Exhibit "A" to Amendment No. 1

Subject: City Delray Beach Water Treatment Progressive Design Build Project
Change Order Number 1

A. Water Plant Capacity Increase

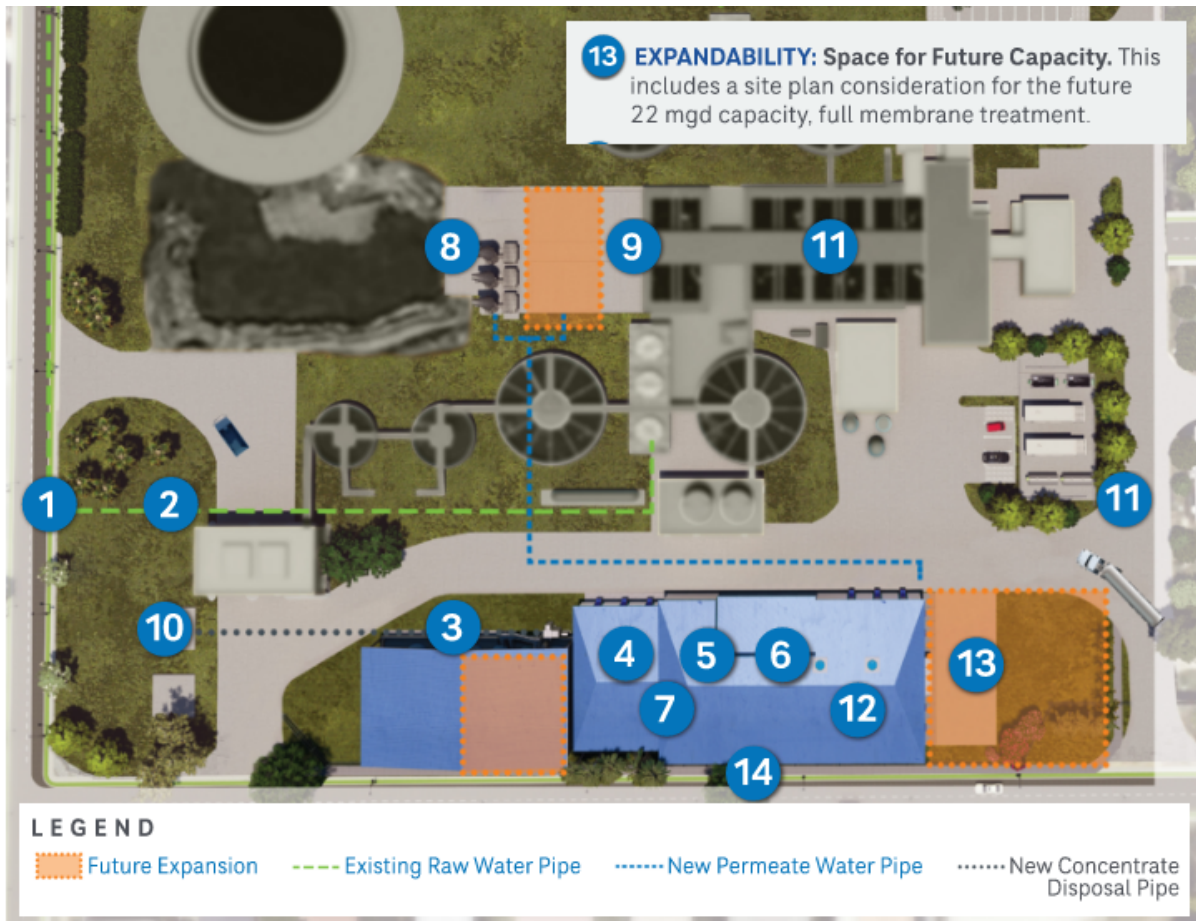
Meeting the requirement for "flexibility to expand treatment capacity to 22 MGD" was to be accomplished by expanding the membrane building in the future. The current design was to include yard space for a building expansion to accommodate a capacity increase to 22 MGD. It was not the intent to install a building sized for 22 MGD at this time, but to just design a building sized for 14 MGD. This design intent is corroborated by the site layout shown on page 75 of the Design-Builder's proposal as shown below.

The project scope has changed from a 14 MGD membrane process train addition, to a full replacement of the existing lime softening facility with a building sized for 25 MGD and installed process capacity of 22 MGD.
